**City of Portland, Maine - Building or Use Permit Application**  
 389 Congress Street, 04101 Tel: (207) 874-8703, Fax: (207) 874-8716

Past Use: Single Family  
 Proposed Use: Same: Remove existing 14' X 20' Garage and Replace with 22' X 24' Garage w/ Room above. Call David at 878-3922 when ready.

BUILDING PERMIT REPORT

DATE: 13 June 2001 ADDRESS: 1806 Washington Ave. CBL: 352-C-001

EXISTING PLAN

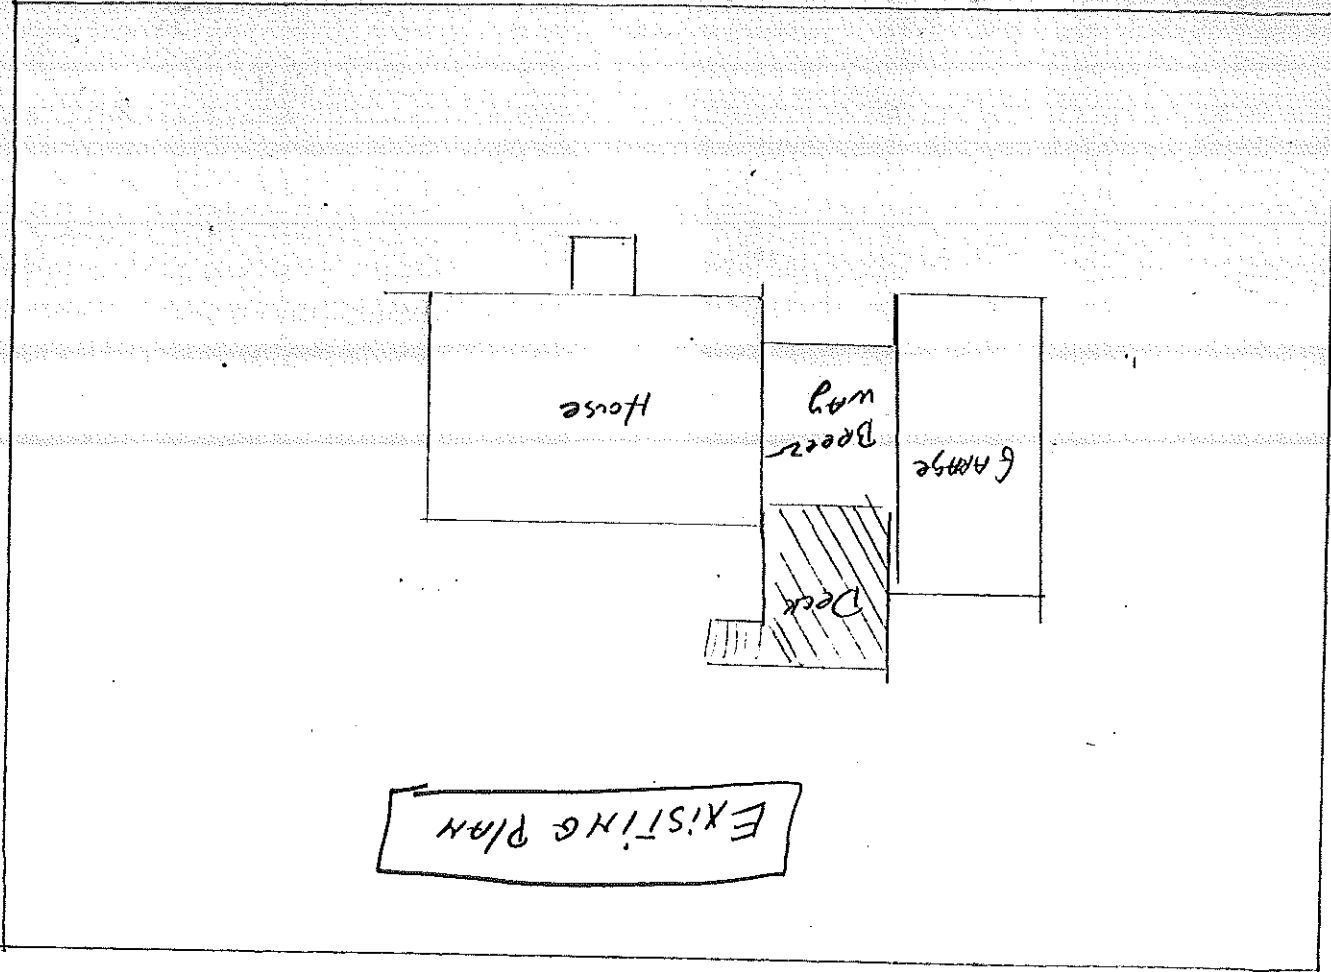
38. The proposed steel beam shall require a statement of design sent to this office by a professional structural engineer, before work is started.
